Our Ref: 2998 - St Gabriels

Your Ref: 135278/FO/2022

RE: St Gabriels – Discharge of Drainage Condition 13

We have been commissioned by our client (McLaren) to discharge **Planning Condition 13** associated with the Planning Permission reference 135278/FO/2022.

DISCIPLINE			SCALE
CIVIL			1:250
DRAWN	DESIGNED	CHECKED	APPROVED
JD	JD	GB	GB
DRAWING No			ISSUE
2998-MHT-Z0-XX-DR-C-00110			C13

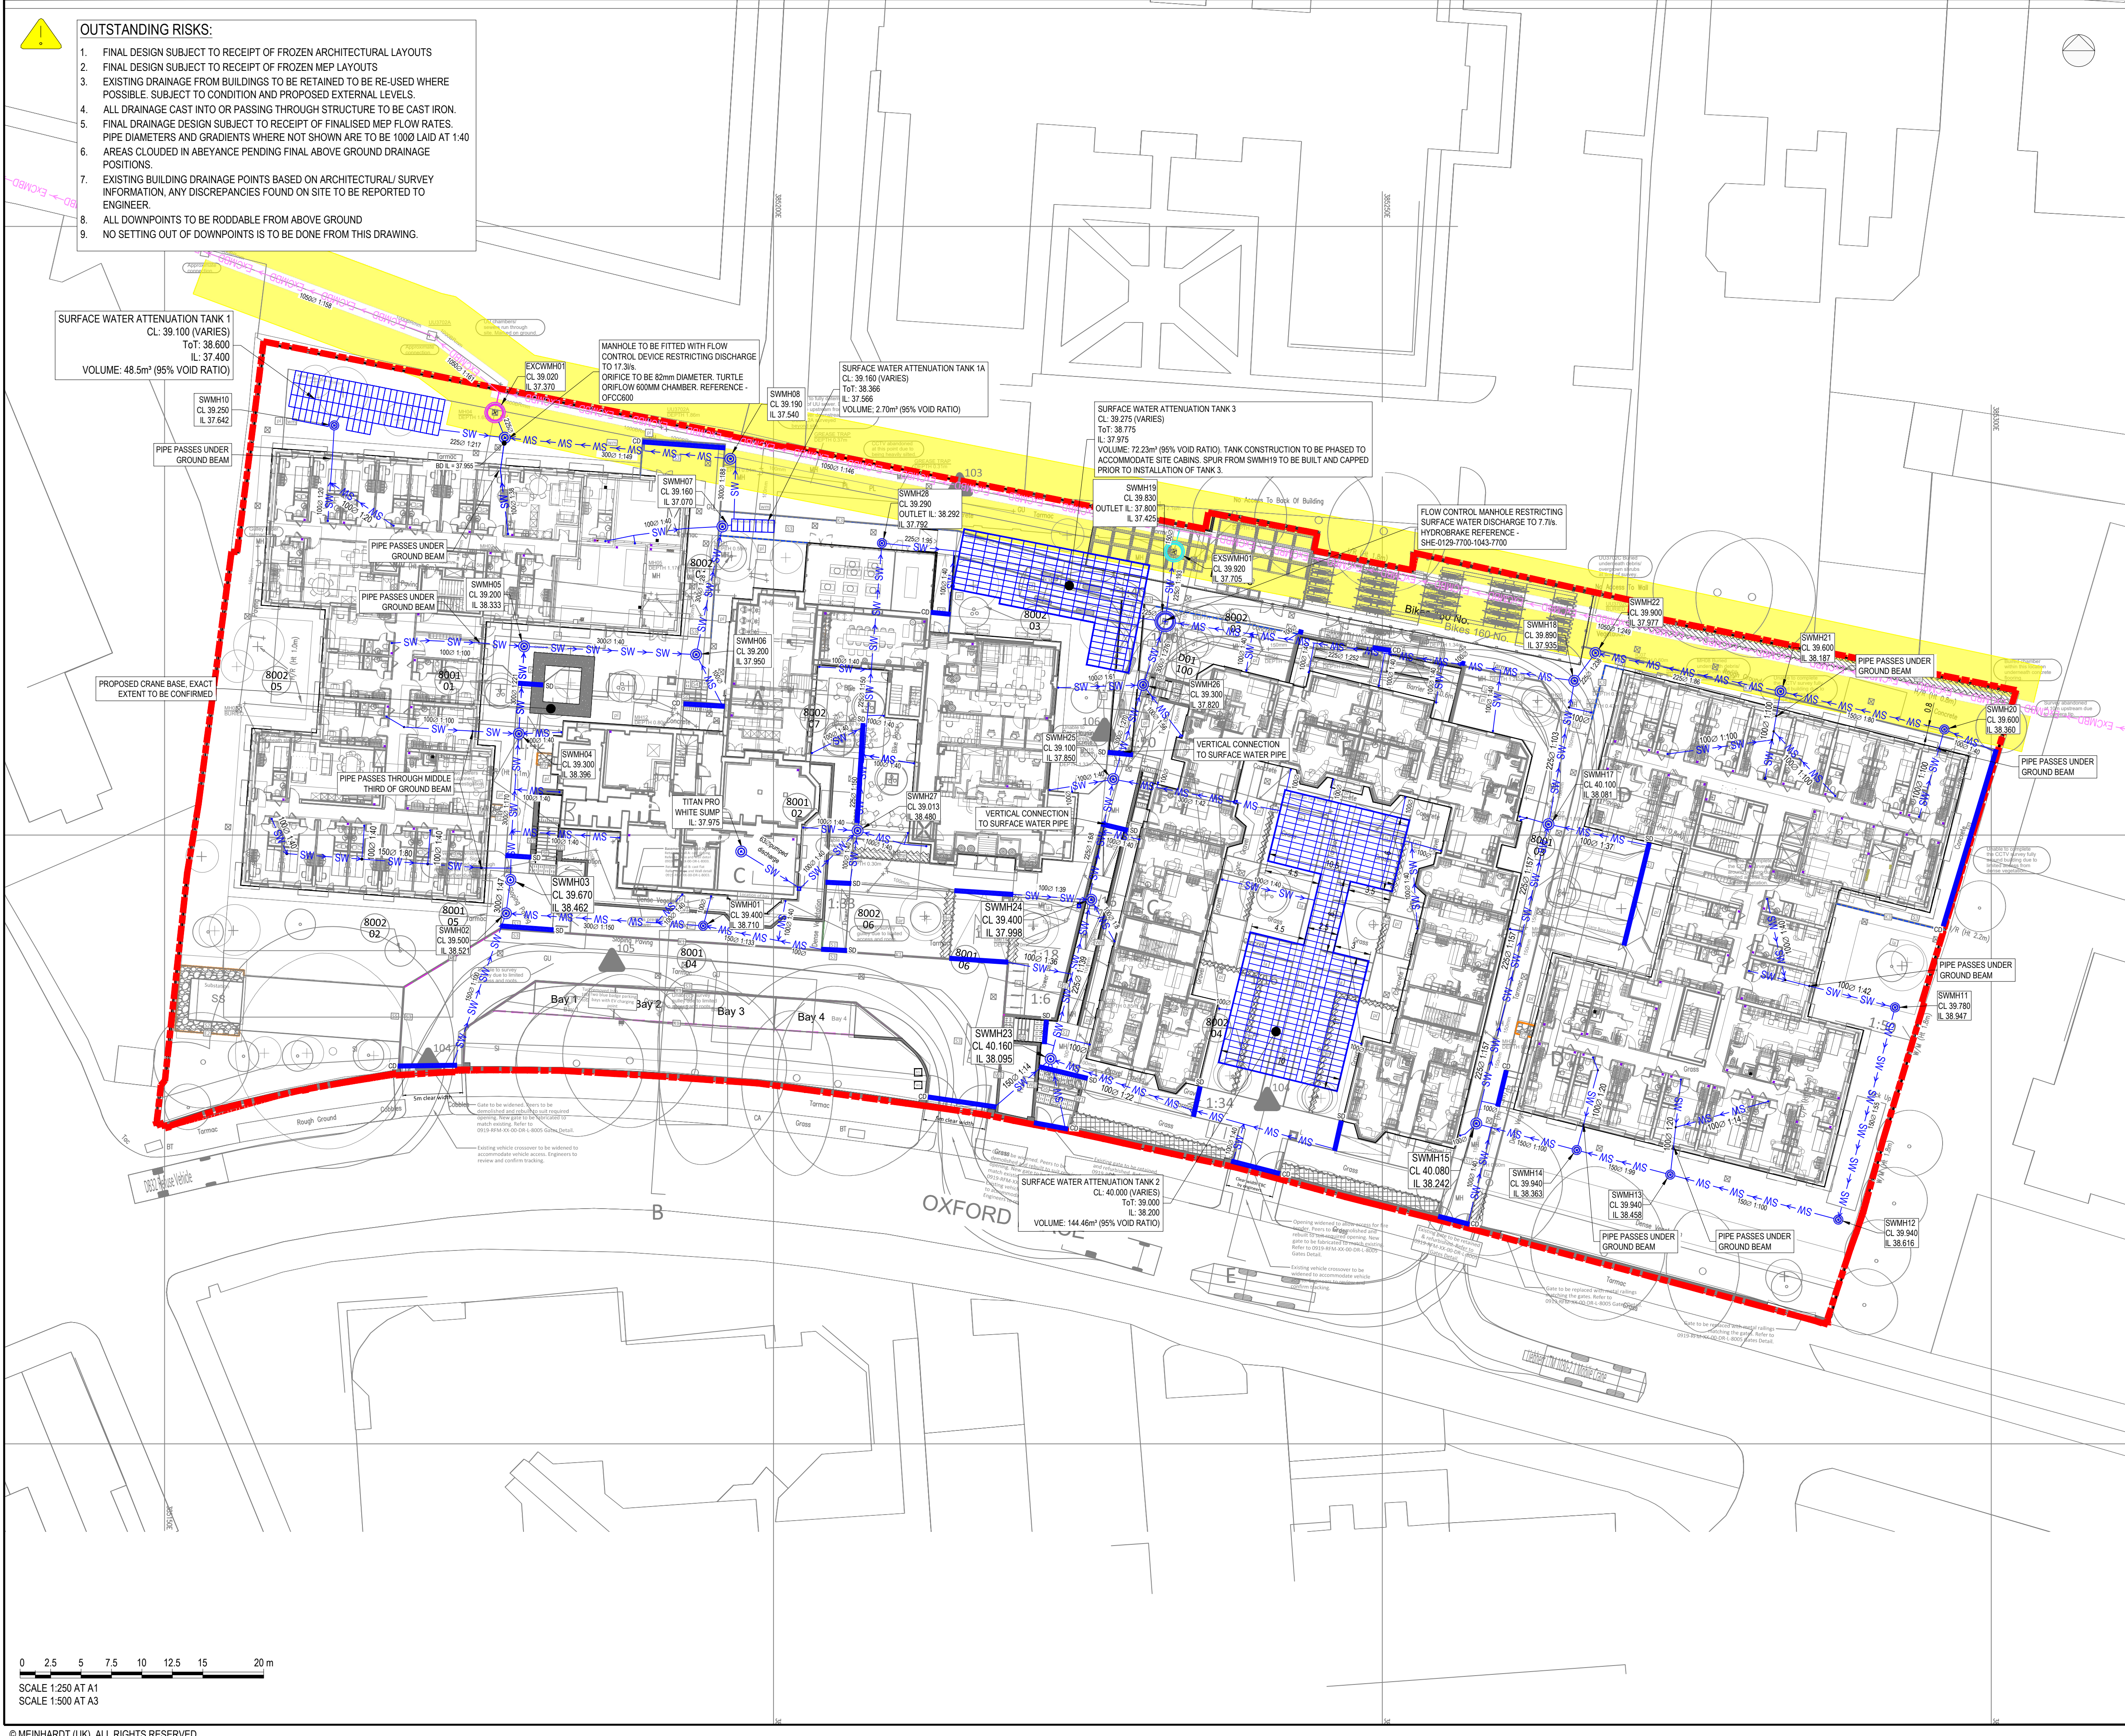
These layouts reflect the updated drainage design including revised attenuation tank locations and sizes. All SuDS components, flow control chambers, and pipework have been coordinated with architectural and structural layouts. Easements from proposed attenuation tanks to nearby buildings and site boundaries have been maintained as per United Utilities guidelines. An easement overlay has been added to the drainage drawing to confirm that attenuation tanks are located outside the sewer easement extents. Refer to Drawing 00110 Rev C13 for confirmation.

A minimum easement of 1.7 metres has been provided from Attenuation Tank 1, and a minimum easement of 3.5 metres to buildings from Attenuation Tank 1A. In relation to Tank 1, the adjacent

building foundation has a base of foundation (BOF) level of +38.140m AOD. With a conservative 45° load dispersion allowance, the zone of influence extends laterally and vertically below the foundation. The invert level of Tank 1 is set at +37.400m AOD, which lies outside of and below this zone of influence.

On this basis, the reduced easement (1.7m from Tank 1 to building) does not compromise building stability or the performance of the attenuation tank. The foundation and tank therefore operate independently without conflict, satisfying the structural protection principles of the SuDS Manual (C753).
